System Energy Resources, Inc.
1340 Echelon Parkway
Jackson, MS 39286-1995

CNRO-2005-00054

SUBJECT: Grand Gulf Early Site Permit Application Revision 1 Corrections (TAC NO. MC 1378)

On September 7, 2005, the NRC requested clarification of some apparent discrepancies in Revision 1 of the Emergency Planning Information, Part 4, of the GGNS ESP Application (Reference 6). On September 14, 2005 a conference call was conducted to discuss the discrepancies and the necessary corrective actions.

Figure 3-1 (1 page)

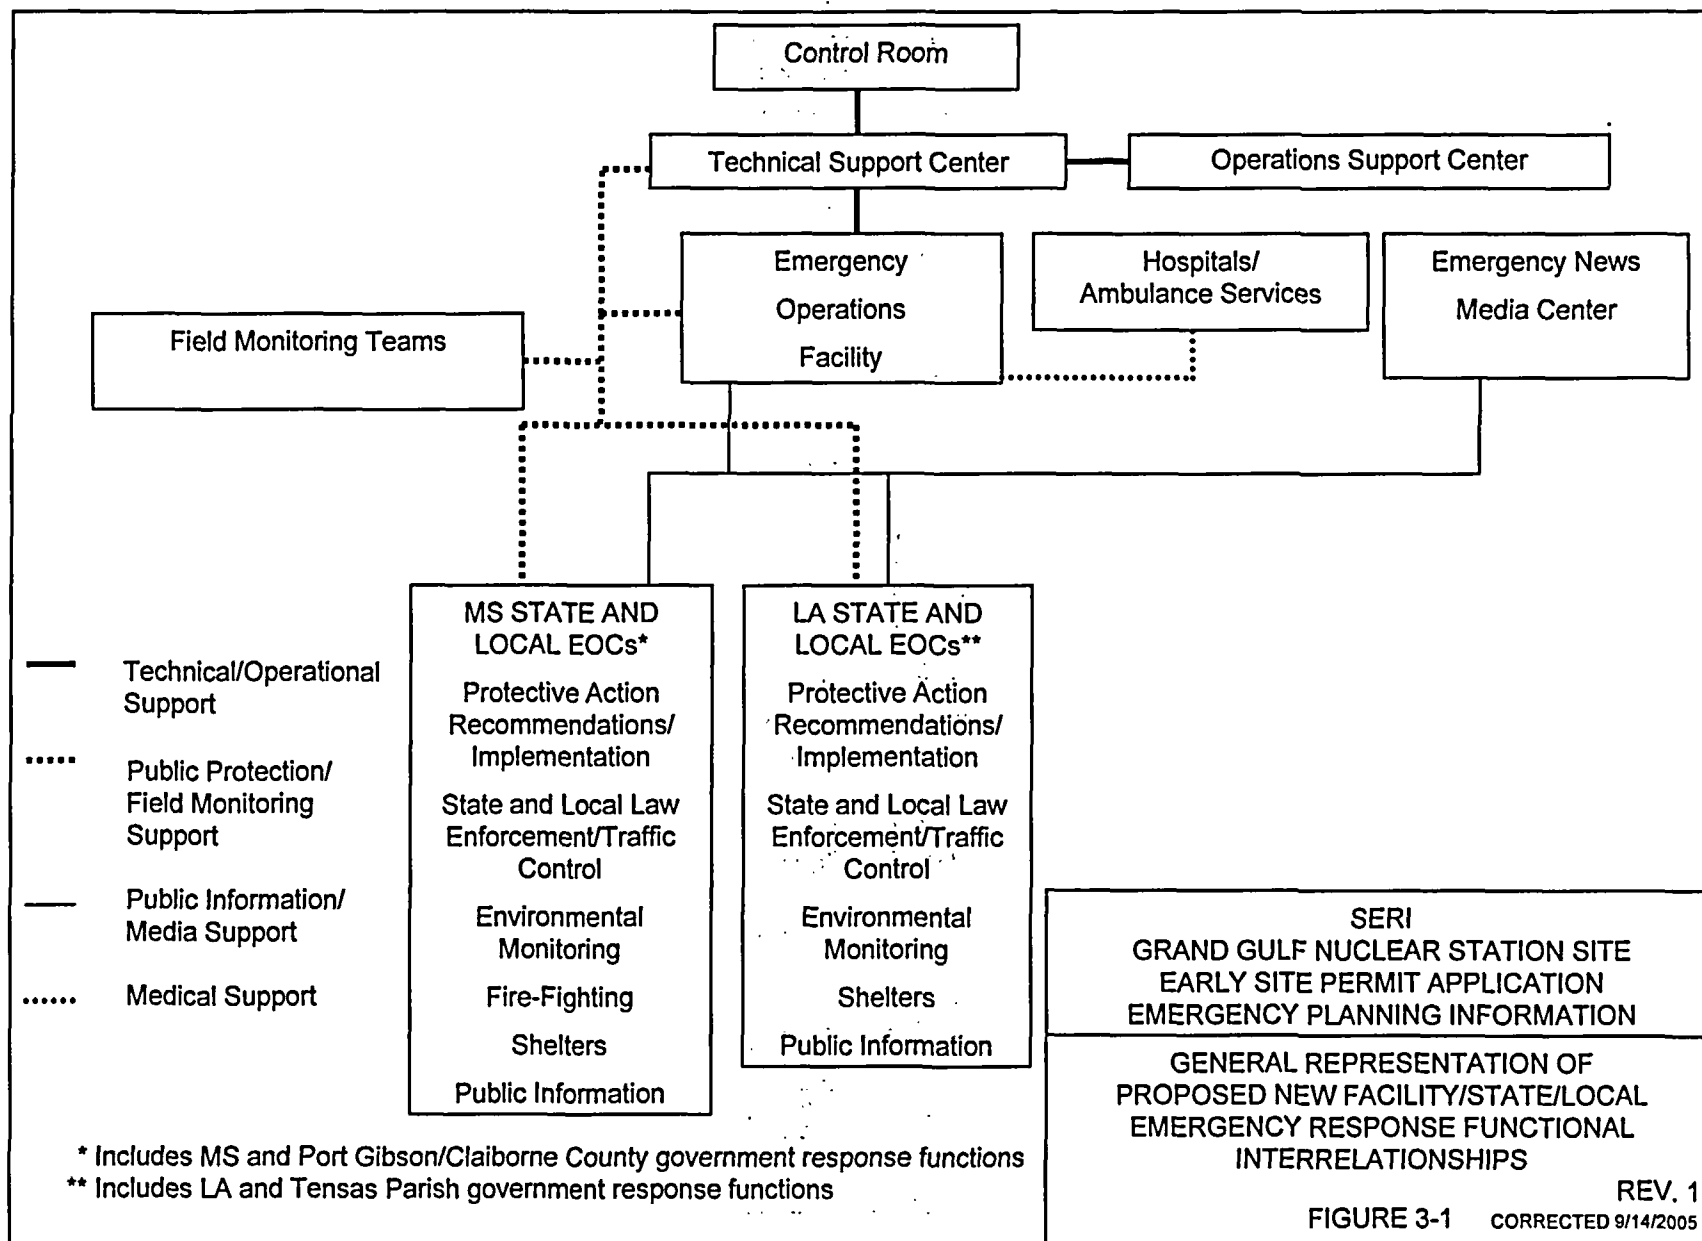
Action #2: Provide justification for deleting changes made to Figure 3-1 and Table 4-1 in draft Revision 2 made to address RAIs 13.3-13 & -57, or restore changes identified in draft Revision 2.

The version of Figure 3-1 and Table 4-1 in the draft Revision 2 document should have been incorporated into the Revision 1 files. They were inadvertently omitted. Corrected Tables are included with this letter.
